Tel-Aviv metro M1 North Assessment of NTA planning

for
The region of Drom Hasharon and the municipalities of
Herzliya – Kfar Saba – Raanana – Ramat Hasheron

doc.ref.: M1-North-Planning-NTA-Assessment-v06.docx
version: 0.6
date: 18-01-2021
author: Dick van Bekkum

figure 10.1

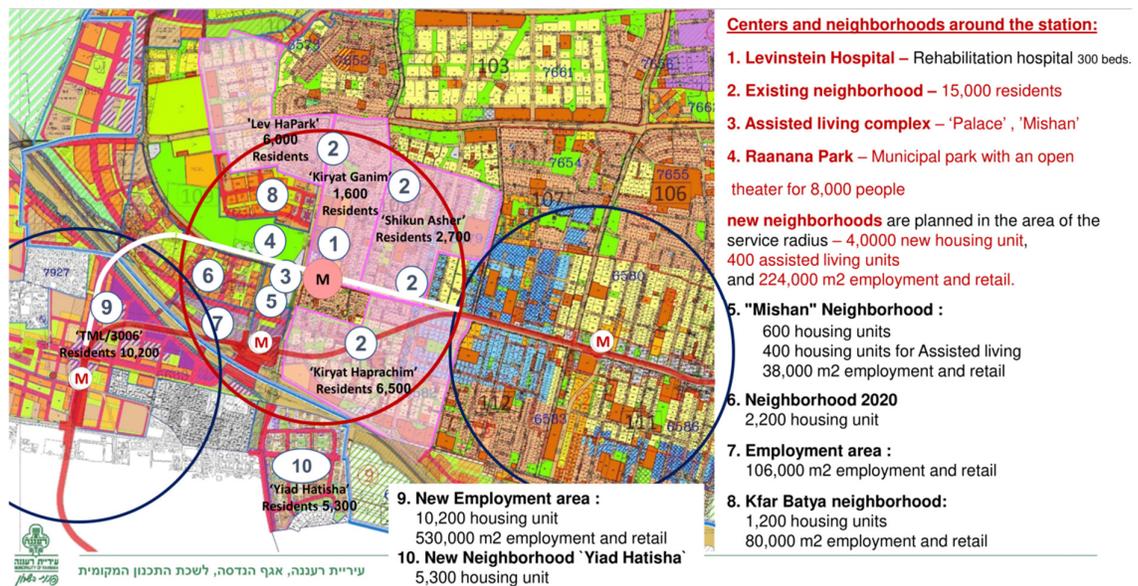
And as a third there is the question of the level of service by M1 of central Raanana. The municipality summarized a couple of things in figure 10.1.

The figure shows what would have to be served by station West in south-western Raanana. The coverage circles in figure 10.1 are a little misleading, because they have a radius of 800 m. That assumes an acceptable walking distance of 1000 meters, which is far too optimistic. A circle with its center point at the intersection of Ahuza St and Jerusalem Rd lists what is needed. Especially a good public transport facility near the Loewenstein Rehabilitation Hospital is crucial.

The planned alignment will run directly under residential buildings in Kiryat Haprachim and along Schwartz St. That represents a serious risk for ground borne noise and vibrations which must be carefully investigated. Also the risks of damage by the M1 construction has not been made explicit. The alignment under Ahuza St is much better.

figure 10.2

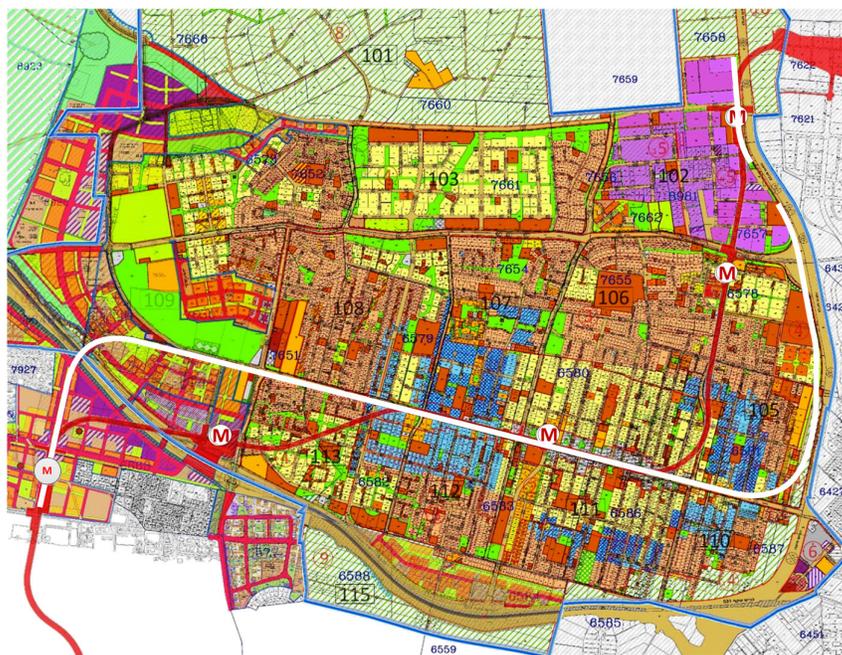
- from Ahuza St straight on via Park Path and then turn to the south to connect with IDC station in Herzliya;
- from Ahuza St around eastern Raanana and parallel to highway 4 to the north.

The first proposed change must be followed by a new location for a station in the west of the city (see chapter 11). Special attention must be paid because this alignment will pass through two water wells. During construction measures must be taken to avoid pollution of the water.

The second one is expected to cause much less intrusion due to construction and has a lower risk of noise and vibration during operations.

figure 11.1

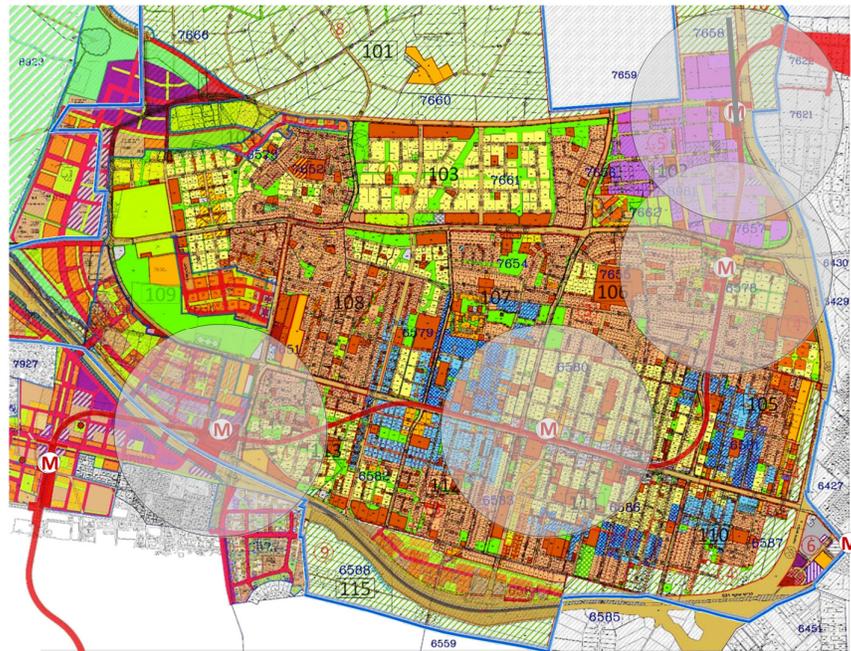
The average distance of stations is slightly less than 1200 meters, but the distribution of three distances is very uneven: 1777, 1898 and 690 meters. Between Akiva and Center, even along the line, the maximum acceptable walking distance of 800 meters will not be reached. Figure 11.1 illustrates that fact. The maximum acceptable walking distance is assumed to be 800 meters, which results in coverage with circles in the figure, having a radius of 640 meters.

Figure 11.1 shows that the present plan provides rather poor service in western central Raanana, especially caused by three stations located relatively far from one another.

figure 11.2

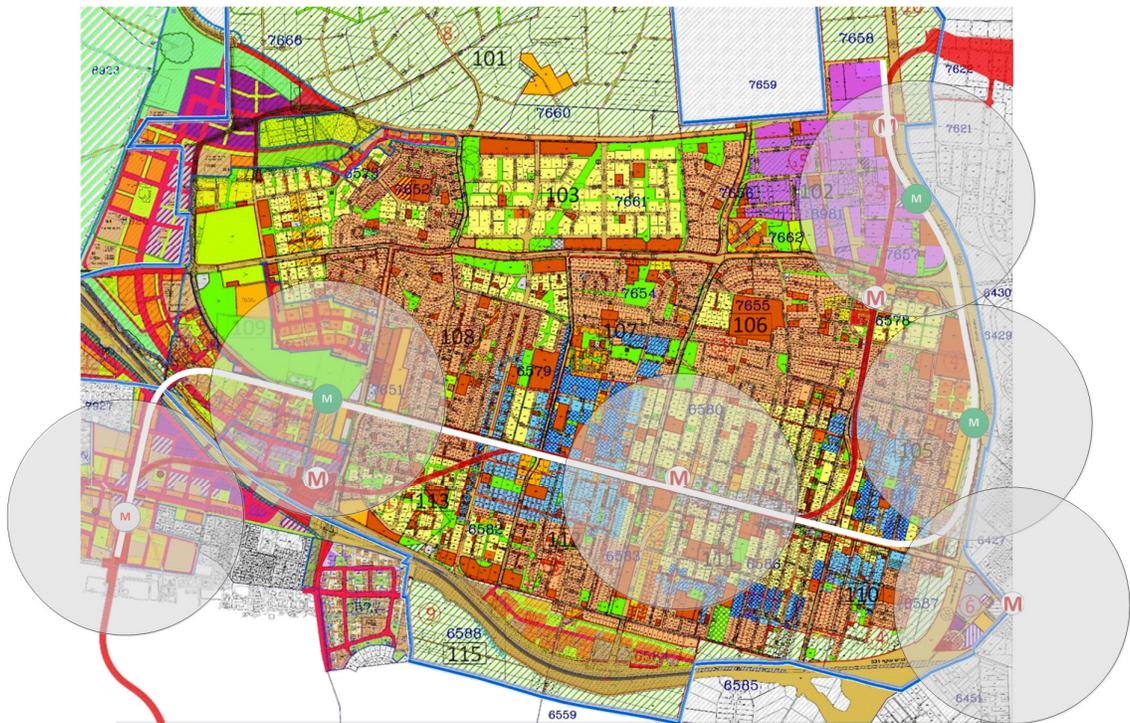
The alternative is to skip the stations West and Akiva and have four stations along the alignment with three of those at different locations (see figure 11.2).

The station West should be relocated to Ahuza St close to Jerusalem Rd. Another station should be located around Yaara St on the east side of the city adjacent to highway 4. And Tidhar station should

be moved a little from its planned position to around HaNofar St north of the highway 4 interchange. The last two stations should have underpasses or walkway bridges over the highway for easy access to and from western Kfar Saba.

figure 16.1

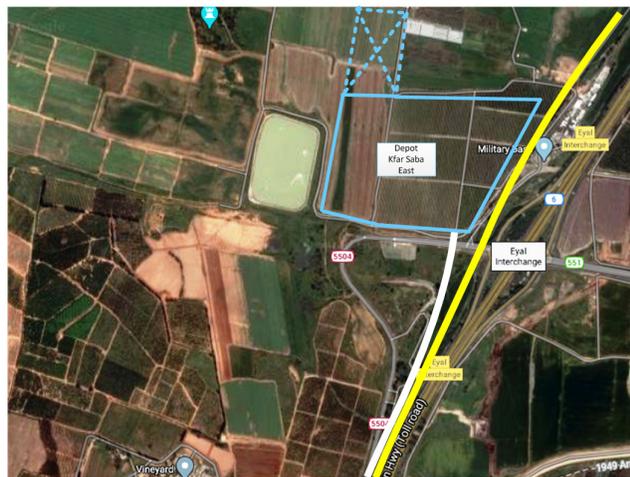
It is proposed to plan the M1 north depot in an area just north of the Eyal-Tira interchange of highway 6 and south of Tira. This is considered a much better location because there will be much less environmental intrusion and there is plenty of space (see figure 16.1). The yellow line represents the alignment of the railway and the white line represents the alignment of M15 at ground level.

figure 16.2

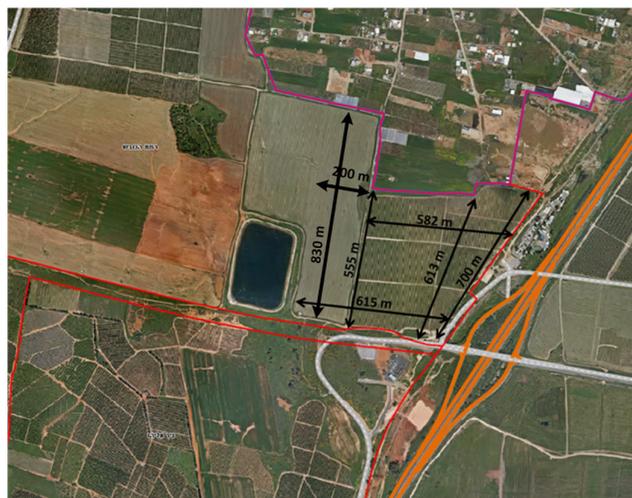
There have been plans for the construction of a land port in this area, which means that this area is so-called planning area at Israeli state level. The dimensions are shown in figure 16.2.

The total surface of the available area is approximately 375,000 m², indicated with a blue lined polygon in figure 16.1. If necessary, more space can be made available on the north-western side (indicated with a dotted blue polygon and a blue dotted X). That would increase the area with a maximum of 200 x 275 meters or additional 55,000 m², compared to the 380,000 m² in Kfar Saba north-west.

figure 17.1

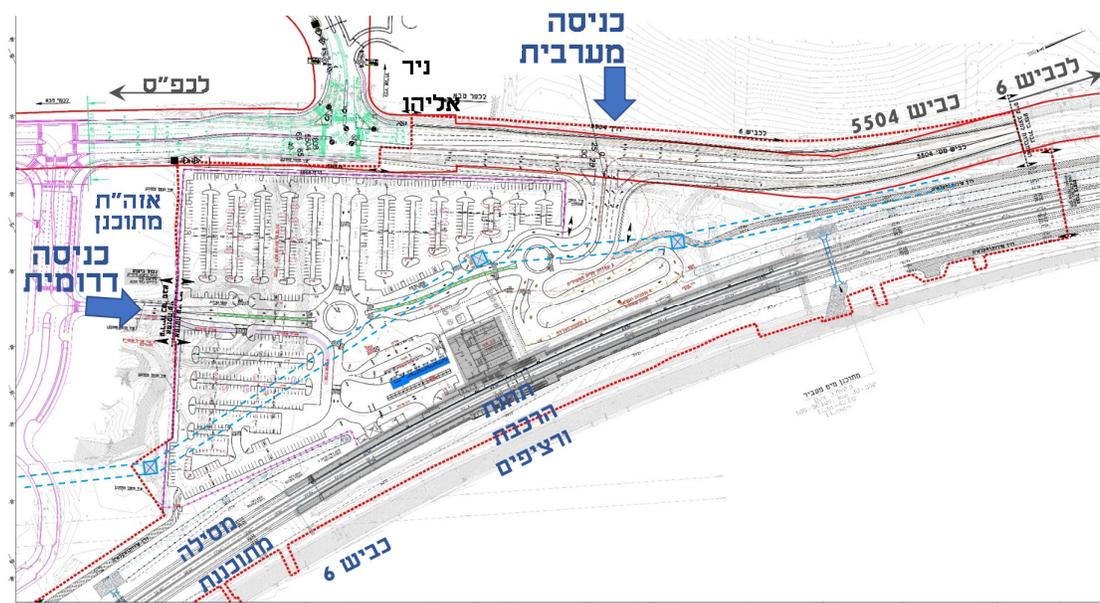
The present end of the line and the last station serves the citizens of Kfar Saba east. M15's last station lacks the possibility for a park-and-ride facility and it will not serve as an attractive location to change from car to metro. Furthermore there are serious plans to construct the so-called eastern railway, connecting Hadera and Lod and a station is planned next to Nir Eliyahu (see figure 17.1).

At this point in time, it is designed as a railway-only station. It would serve two tracks and the plan includes parking space adjacent to the station.

The station is directly east of Nir Eliyahu and not too far from the industrial area in the triangle of highway 6 and road 5504. But the air distance to M15 station Kfar Saba east will be almost 2.5 km, not close enough to be attractive.
